PART 5: Development Presentations

Item 5.1

Ref: 18/05280/PRE
Location: 103 to 111 High Street, Croydon, CR0 1QG
Ward: Fairfield
Description: Erection of 29 storey building, to provide 121 residential units, with commercial units at ground and mezzanine floor level which can be used as retail (A1)/ restaurant (A3)/B1(office) and with office (B1) at first and second floor levels.
Drawing Nos: Pre-application pack
Applicant: Leos North London Ltd
Agent: Savills
Case Officer: Barry Valentine

Fig 3 – Ground Floor Plan

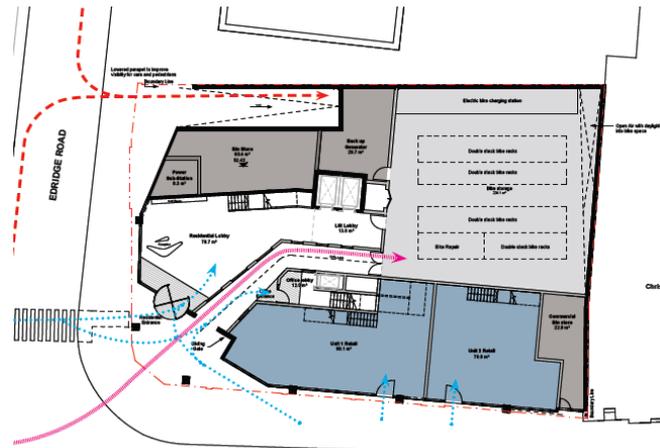
- 6.4 In principle the (re-)provision of retail (A1) and restaurant (A3) at ground floor level is in line with policy. In regards to potential office (B1) provision at ground floor level, it is unclear how the applicant will ensure that active frontage would be maintained and would not undermine the retail function of the frontage. The existing units on the site represent the only 'retail' elements within this frontage. This matter will need to be discussed with the applicant further, but officers consider that the complete loss of the ground floor floorspace to office would undermine the retail function of the frontage.

- 6.5 The applicant has previously mentioned an alternative type of office provision, based on co-working similar to Tomorrow on the high street (<https://www.tmrw.co/>), which is just north of the High Street. Whilst officers are open to the idea of exploring alternatives, insufficient details have been submitted to date on how this would work.

Fig 5 – Five home floorplan within tower

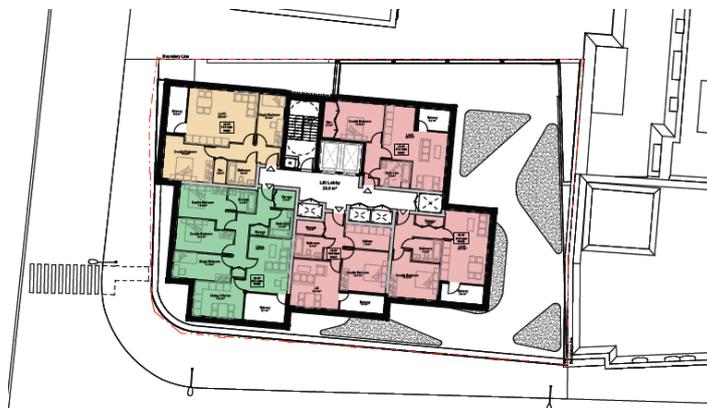
- 6.12 The applicant has provided two typical floorplans. One floor plan that contains five units (3 X1B2P, 1 X 2B 3P and 1 x 3B 5P) and one with four units (1 X 1B2P, 1X 2B3P, 1 X 3B5P, 1X 4B6P). Of the two floorplans all but one of the eight unit types would be dual aspect, with the exception being one of the 1B2P units on the five unit floorplan. However, this unit type is not north facing (faces West). All key habitable rooms are served by generous sized openings, and as such likely to receive good levels of light and outlook. The floorplan of the tower has been designed as far as reasonably possible to respond to the sites constraints, most notably the flyover and western elevation onto Impact House, to ensure good amenity conditions within the units. Residential units are located at 4th floor level upwards, which is above the height of the flyover, thus reducing its impact on units living conditions. In regards to the elevation adjacent to Impact House, the applicant has placed bedrooms here, giving primacy in terms of light/outlook to living/kitchen/dining rooms where residents are most likely to spend their time. The main central core has also been located here as it is less dependent on light and outlook, which also helps protect the privacy of residents in Impact House.

Fig 13 – Extract from applicants initial wind assessment

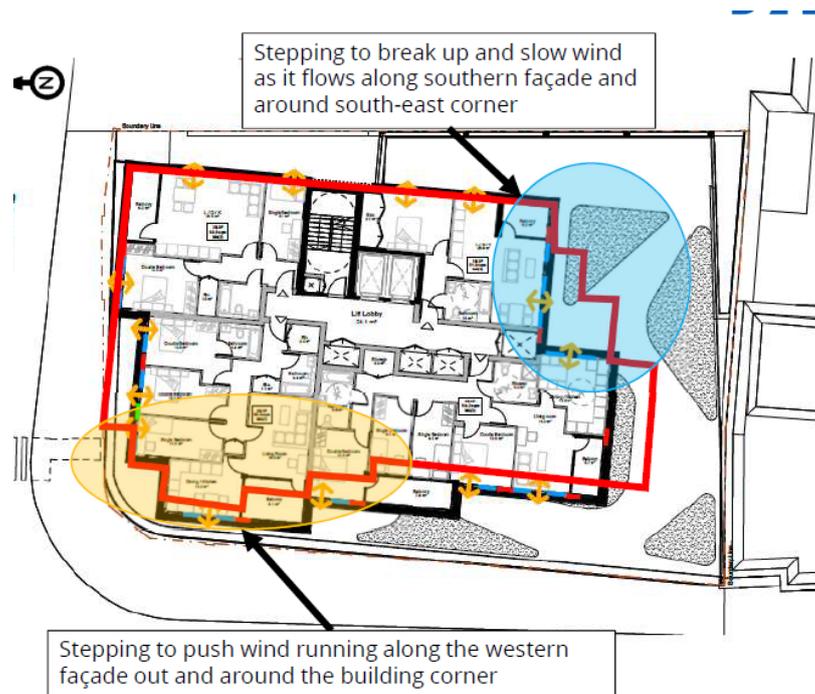
- 6.29 One significant massing point is wind impact. Policy requires development not to cause adverse wind conditions within the development and on surrounding streets. From initial testing provided by the applicant, further changes to the massing are likely to be required to allow acceptable impacts. The tower floorplate changes suggested within the applicant's wind report are shown below in red, with the current floorplan shown in black. This is an area of significant concern that must be addressed before the mass is agreed and taken forward. This will also impact on the elevational design below.

Fig 15 – Distribution of VSC scores below 18%

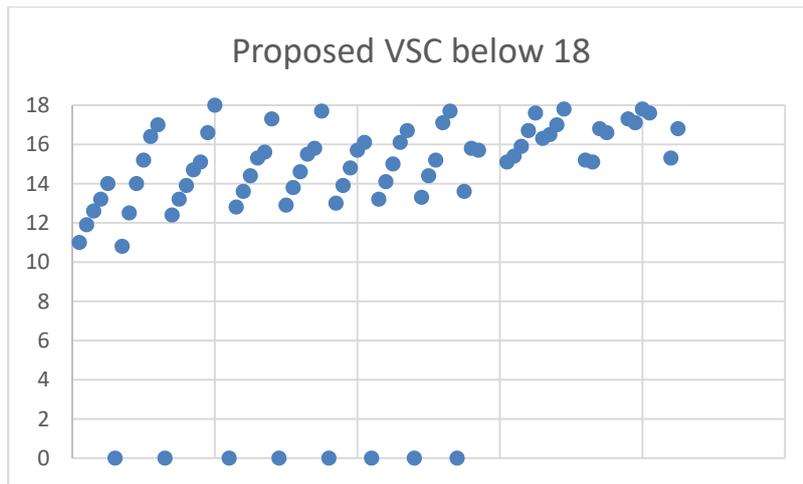
- 6.36 With this reduced target, 74 windows would fail, 58 of which are located within Impact House. The distribution of these failures are shown below.

Fig 16 – Location of Moderate Ratio Failures on Impact House and 96 to 98 High Street

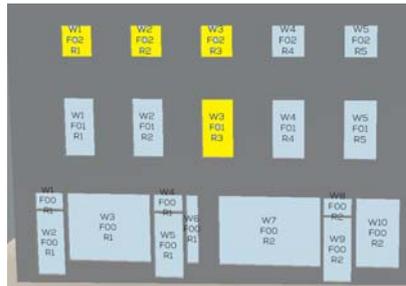
6.37 In terms of VSC ratio reductions, of the 74 windows that has a VSC of below 18, 53 of these failures are classed by Officers to be minor, with a ratio reduction up to 40%, 13 considered to be moderate failures with a ratio reduction up to 60% and 8 major failures with a ratio reduction greater than 60%. All moderate failures are located on Impact House and on 96 to 98 High Street, whilst all major failures are located on the western flank wall of Impact House. These are highlighted in the images below (fig16).

6.38 In regards to these major failures, Impact House was converted from office space to residential units under Prior Approval (ref 15/02723/GPDO), with exception of the sixth to eighth levels of the eastern and western wings, which were added under planning permission (ref 16/04750/FUL). Under the relevant permitted development regulations daylight and sunlight amenity is and was not a valid consideration. Additionally, the developer of this site appears to have given little consideration to protecting the amenity of future residents of their scheme by considering the future development of neighbouring sites when designing their layout. The placing of habitable bedroom windows on a secondary flank elevation whose only source of light is over neighbouring land, and from windows which are unneighbourly by virtue of their close proximity to the boundary, is poor design. So whilst the impact of the proposed development on the light and outlook of bedrooms within Impact House is extremely high, it is not considered appropriate to limit the development potential of this site on this basis.

6.39 In regards to the major VSC failures on the sixth to eighth floor within Impact House, the layout of these affected units is a more appropriate design response than the permitted development scheme, with the relevant windows being a secondary window to a larger living/kitchen/dining room. Given that good sunlight/daylight and outlook would still remain out of the main rear window, the impact of the development on these units would be acceptable.

Fig 18 – Separation distances to neighbouring properties

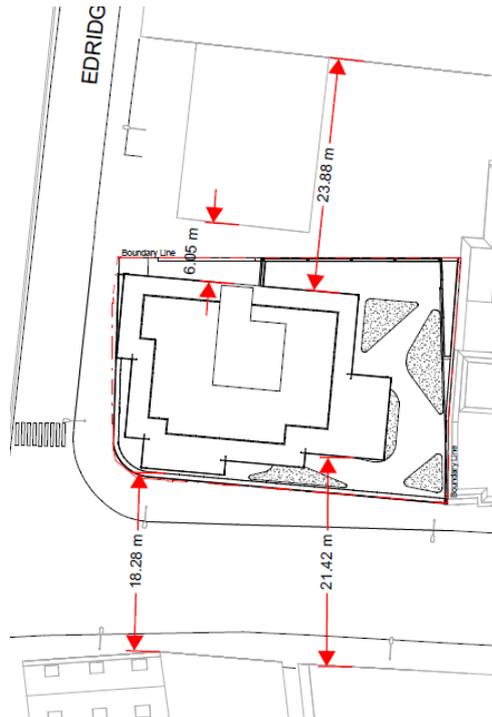
- 6.43 In general, and with exception of the windows on the western flank elevation of Impact House closest to development, very good separation distances of over 18m would be maintained ensuring good outlook would be maintained for neighbouring properties.

Fig 19 – Showing proposed balconies serving commercial properties relationship to Impact House

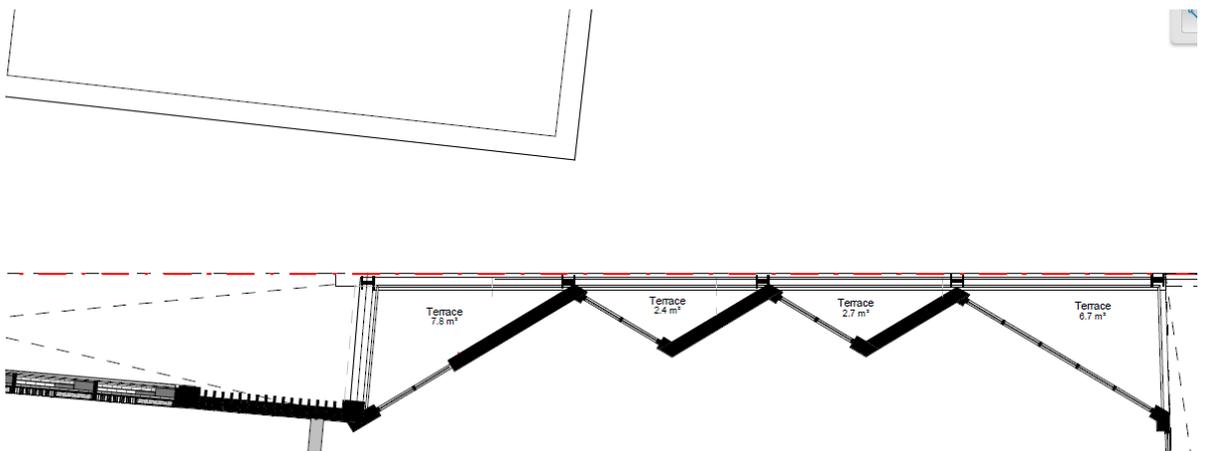
6.44 In general the scheme has been designed to reduce the impact of the development on neighbouring privacy through the appropriate placement and angling of windows. Similarly terraces to residential units are appropriately located such that any view of neighbouring windows would be at significant distance or at obtuse angles. Some further thought and consideration will need to be given on the design and location in regards to podium level amenity space and the terraces serving the commercial units, to prevent development having unneighbourly relationship in terms of both noise disturbance and privacy.
